POWER PLANT - POWERPLANT - ENGINE - INTRODUCTION OF A LONGER BOLT AT CLIPPING POINT
5523 - CATEGORY CODE 6 - MOD.ENG-71-0122

V2500-ENG-71-0122

SERVICE BULLETIN

Location of bolt
Fig.1

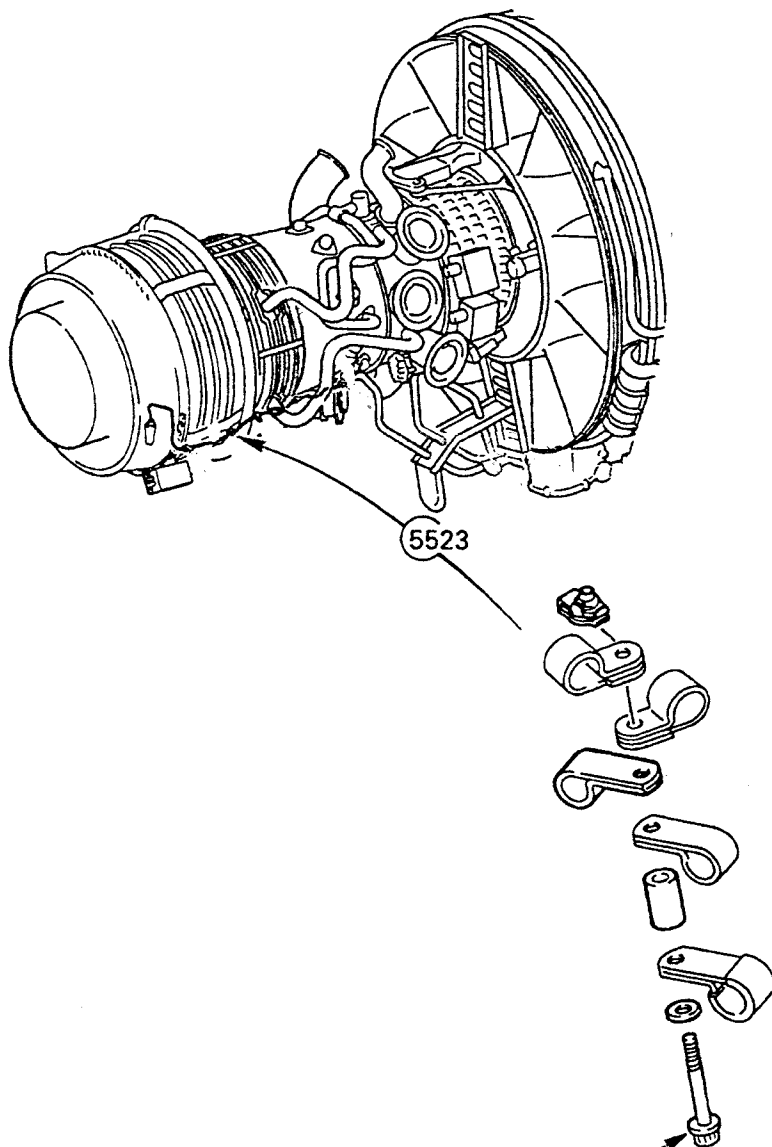
A longer bolt replaces the existing bolt at clipping point 5523.

- (1) Install the 4W0017 bolt in accordance with approved procedures, Engine Manual (E-V2500-1IA), Task 72-00-50-420-005-A00 and 72-00-50-420-005-B00.
- (2) Refer to Figures 1 and 2 of this Service Bulletin

Clipping point 5523 Before and after alteration
Fig.2

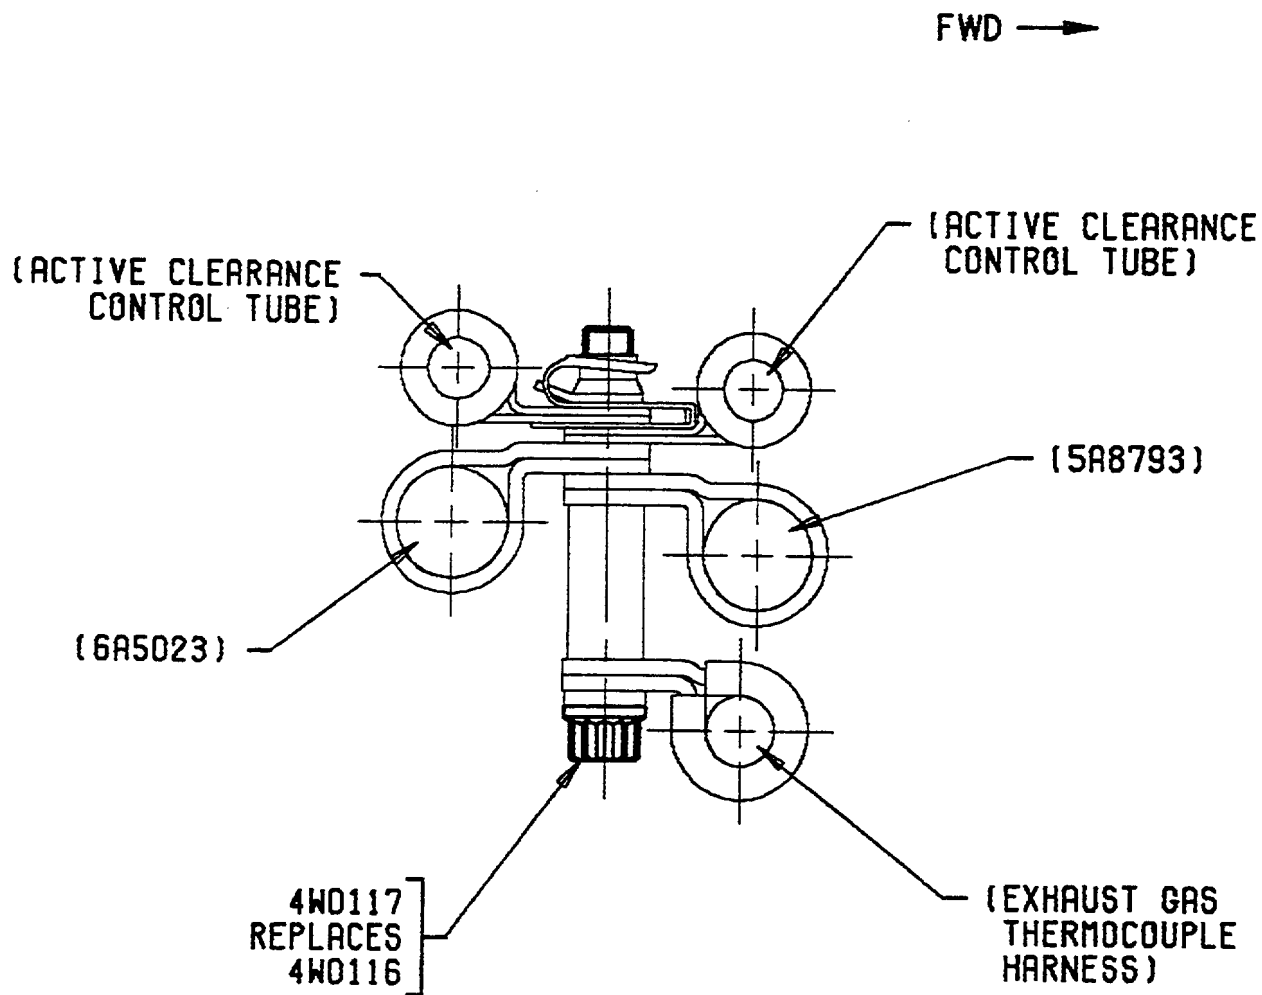
REMOVE 4W0116 AND
INSTALL 4W0117
